# Notice of Allowability

10/781,514

### EXAMINER'S AMENDMENT

FIG.4

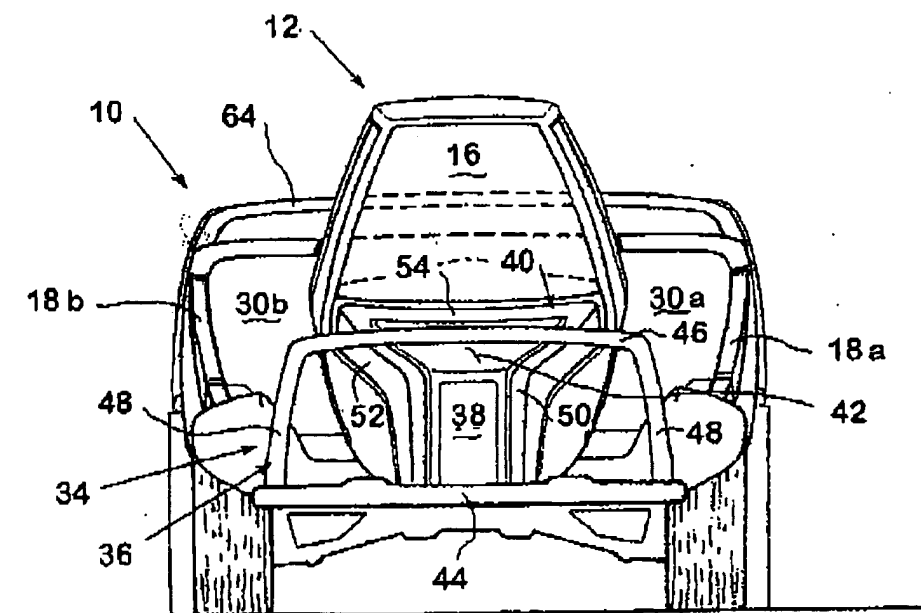
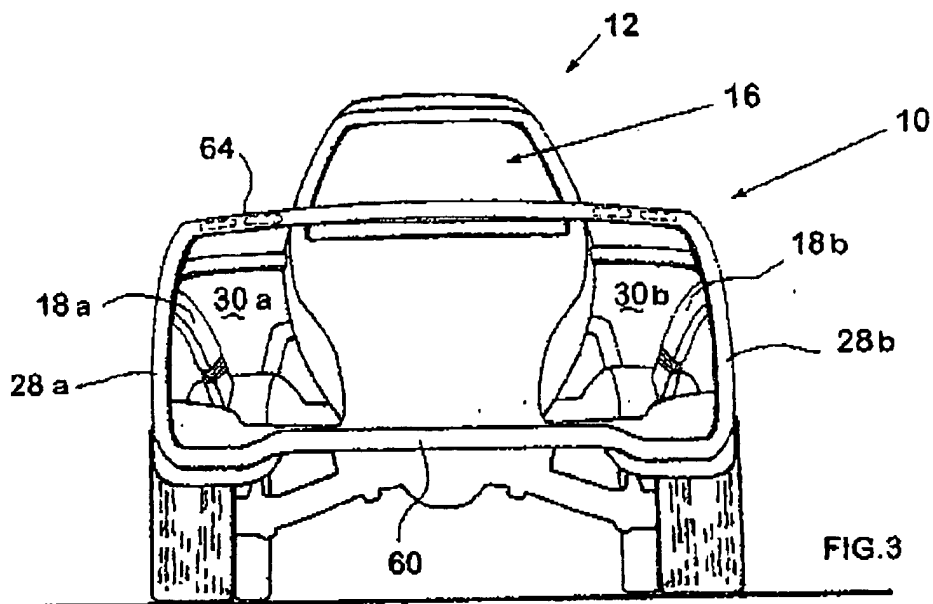
Figure 7 has been deleted from the sheet containing Figures 3 and 4.
